Re: Florida Power & Light Company  
Docket Nos. 50-250, 50-251, and 50-335  
Request for Information

FLORIDA POWER & LIGHT COMPANY  
DOCKET NOS. 50-250, 50-251, & 50-335  
NRC REQUEST FOR INFORMATION  
SYSTEM DISTURBANCE (5/16/77)

GROUP 2  
RINGLING SUBSTATION  
10:24 AM  
5/16/77

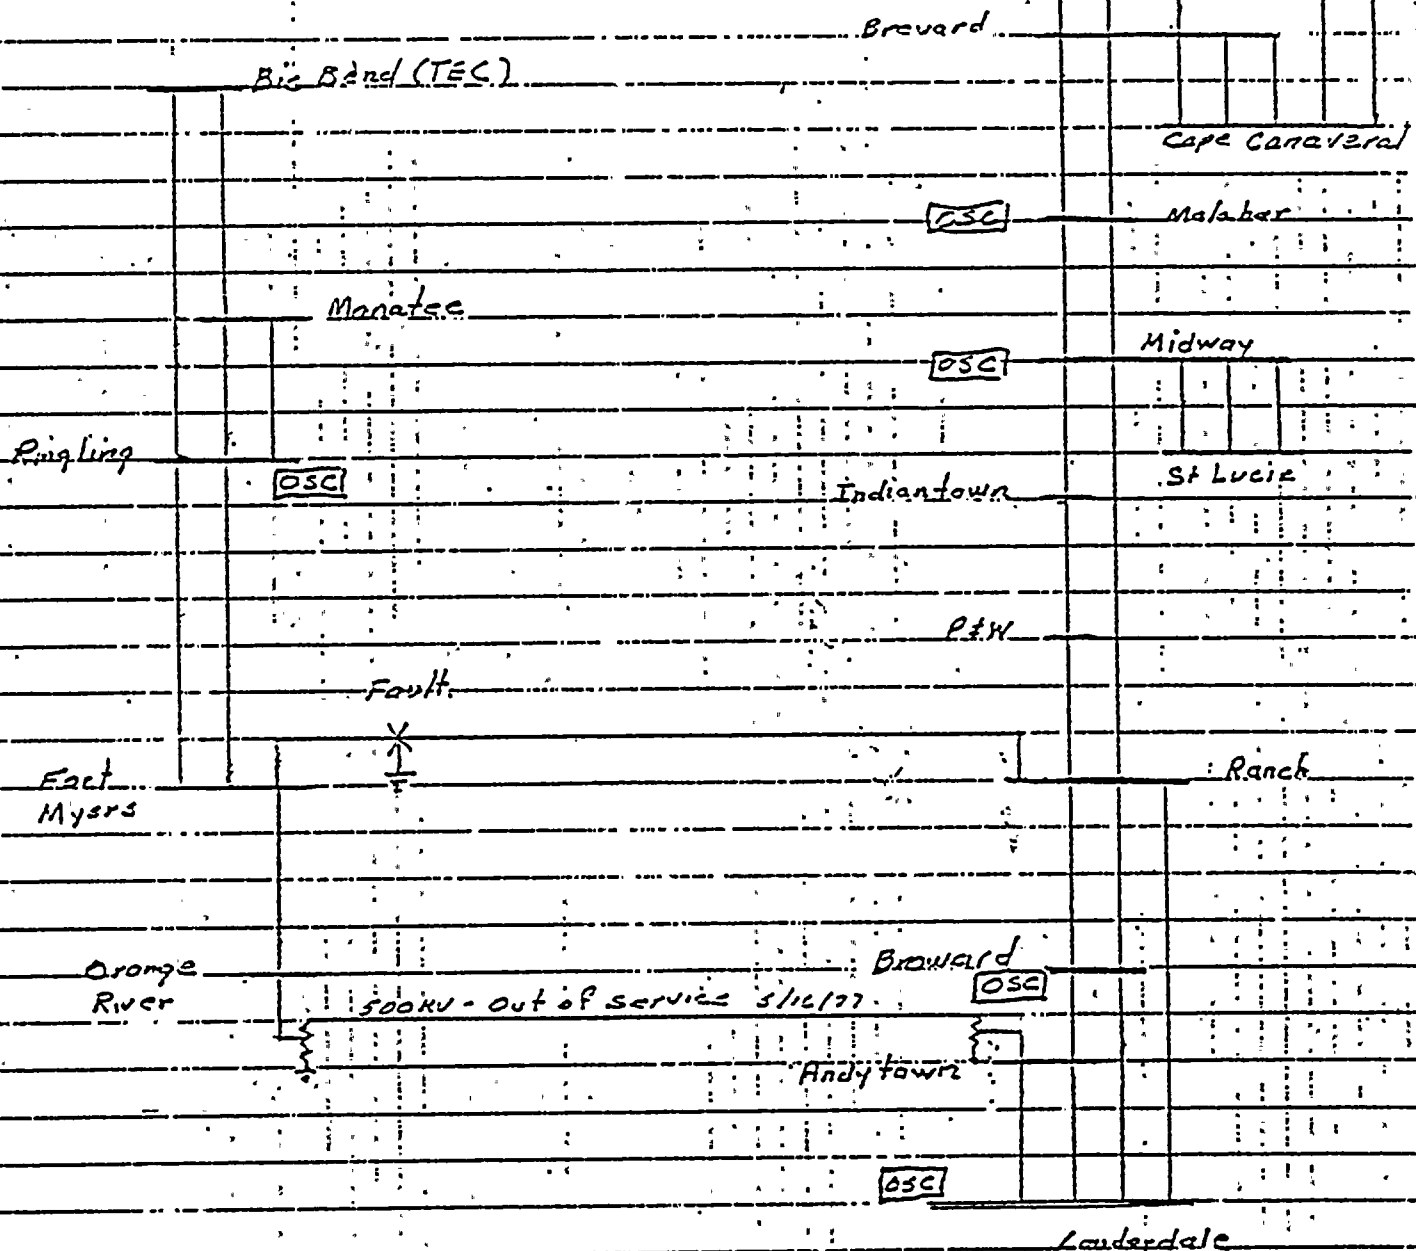
So that we may better understand the causal relationships between the events that occurred on May 16, 1977, please provide the following information:

- 1.1 A time trace of the real power loading on the Ft. Myers-Ranch 240kV line for the time period 10:08-10:24 am;
- 1.2 The normal rating of this line (MW, MVA);
- 1.3 The long time and short time emergency ratings;
- 1.4 If the ratings are given in MW, indicate the power factor to which they apply;
- 1.5 The MVA load (or the power factor) on the line when it relayed open;
- 1.6 If the information in Items 1.4 and 1.5 is not available, provide power factor or equivalent information at points as close to this line as available; and
- 1.7 The line loading information (power, power factor, etc.) on this line for each occasion in the past when it relayed open.

The Fort Myers-Ranch line tripped at both ends with a ground pilot target at Ranch and a Zone 1 and ground instantaneous targets at Fort Myers. Broward, Midway and Ringling oscillographs recorded a phase-to-ground fault at this time. The Ringling oscillogram indicated a "B" phase-to-ground fault.

The attached oscillogram from Ringling shows a discrete step

change in current, indicating a fault rather than an over-current. The oscillograph is a 32 channel machine, but due to play back limitations, the output is printed on three separate pages.

Note step change in current

Unit 3 Trip

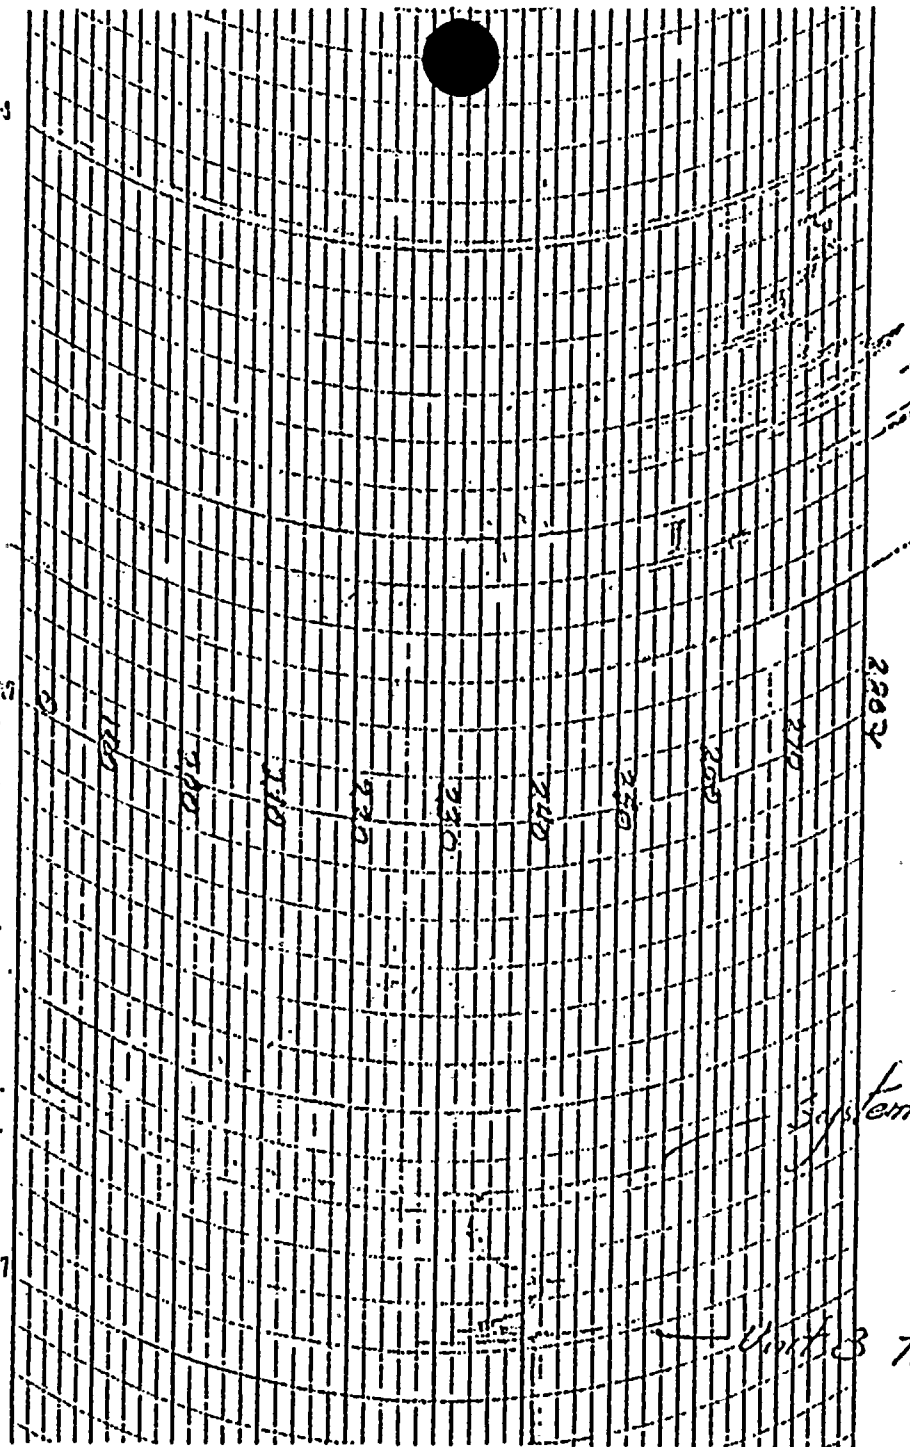
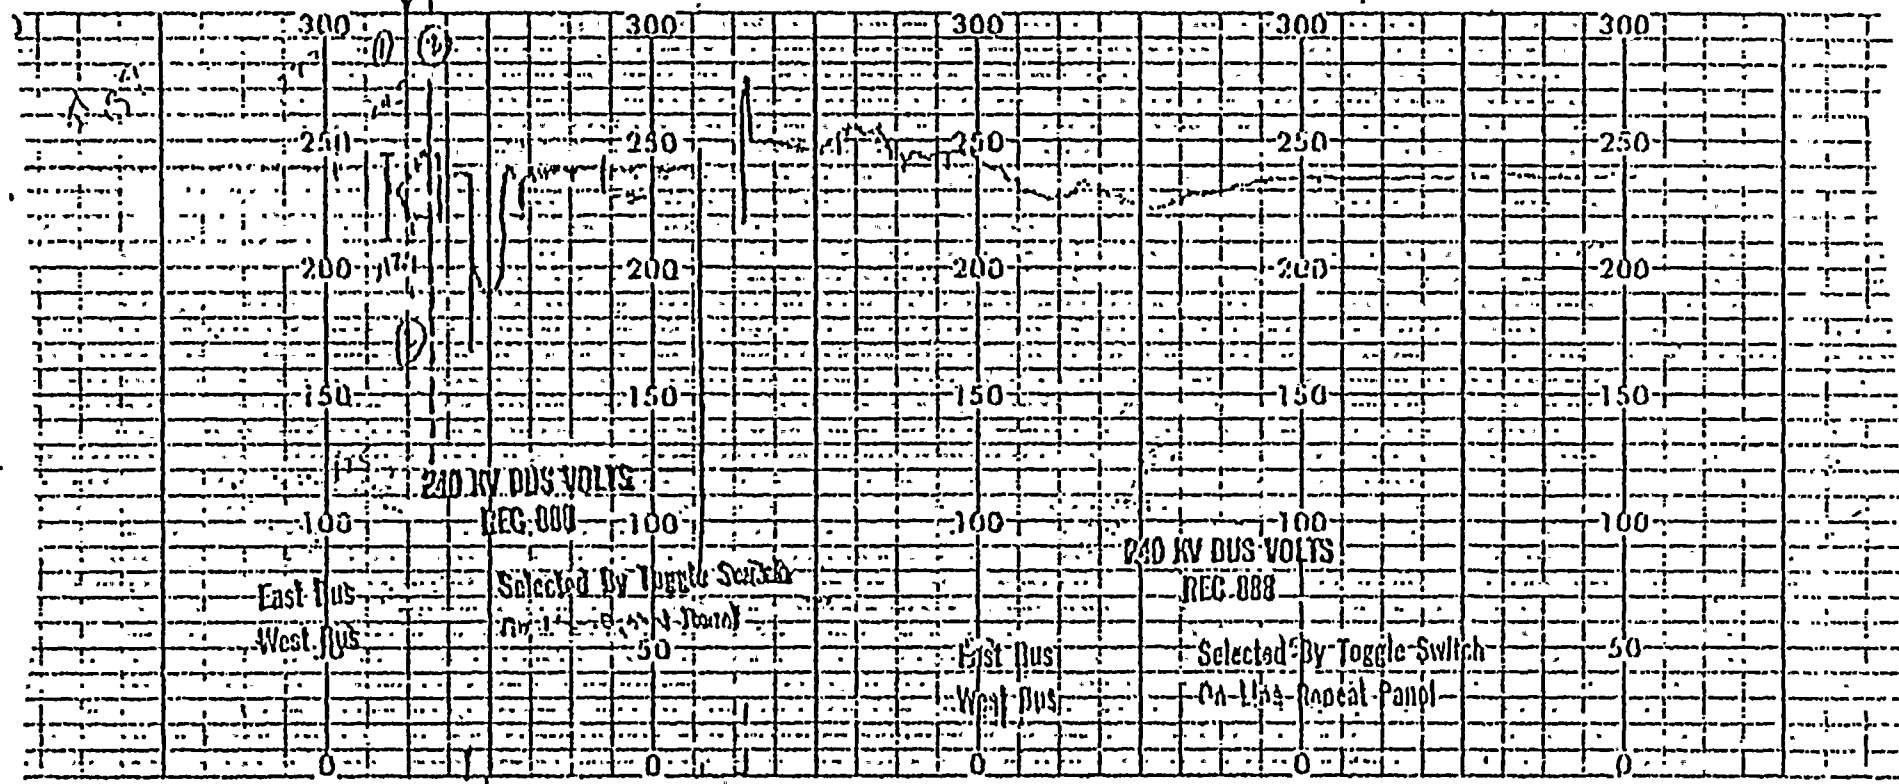
Please provide the following information:

The continuous high speed recorder installed at Turkey Point records bus frequency. Since other parameters are related to generator output, only bus frequency can be provided. No equivalent recording equipment is installed at the St. Lucie Plant.
